The façade design for the 1352 Valley concept, approved with several conditions and revisions in 2013.

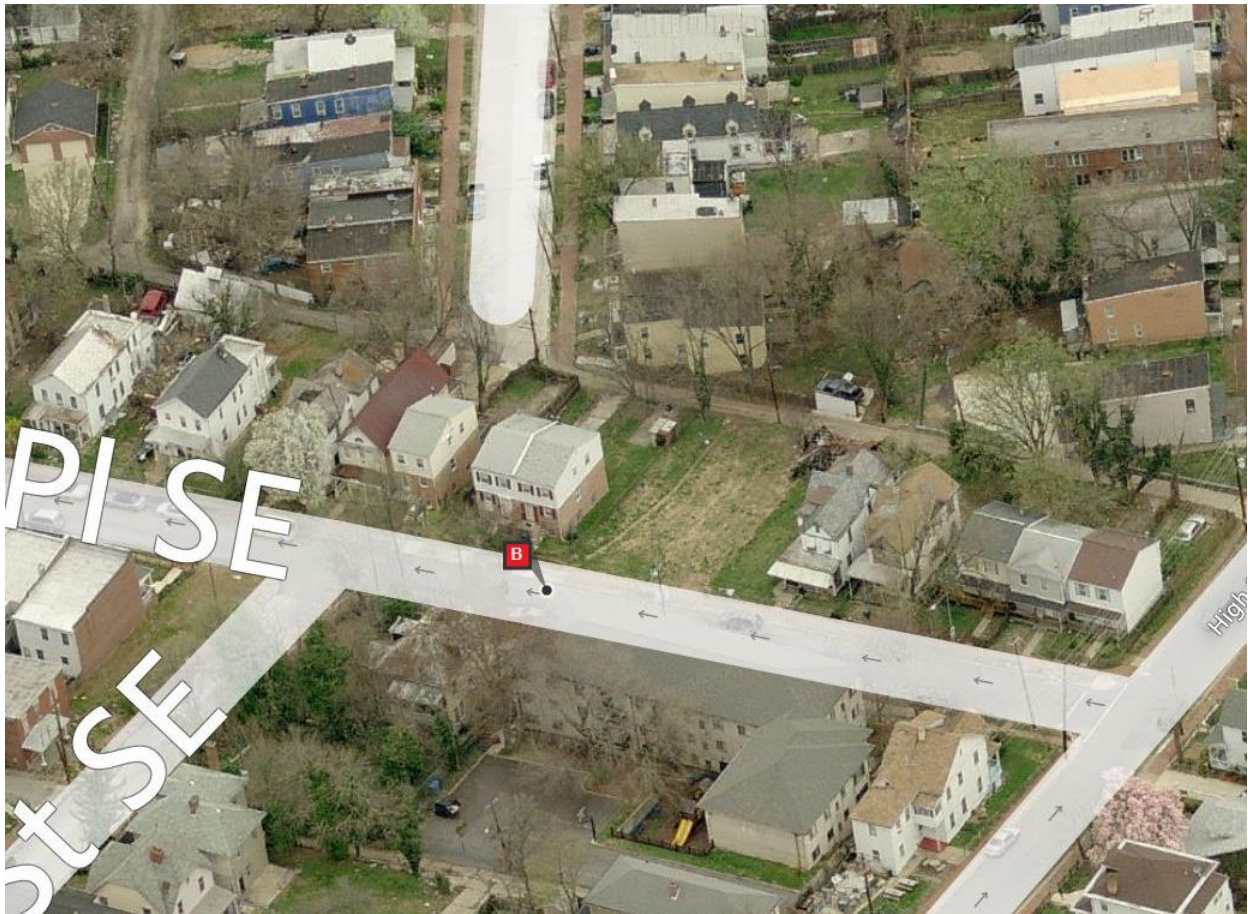
There are the usual concerns about details that have been expressed in previous reports for 1618, 1622 and 1624 U Street, 2221 and 2225 Chester Street, and 1352 Valley, all projects submitted by the same applicant. These include revising the cornice somewhat (properly sized brackets and eave depth, with a frieze behind the brackets); building the vents substantially as drawn; getting right the ridge mold or flashing detail at the roof ridge; ensuring the proper porch balustrade, posts, door and fencing; and making certain that there will be no electric meters in front of the house. The porch is also too shallow. Of course, it will be in the construction itself that adherence to the plans is tested.

The HPO recommends that the Board approve the concept and delegate to staff further review to address the details mentioned above.
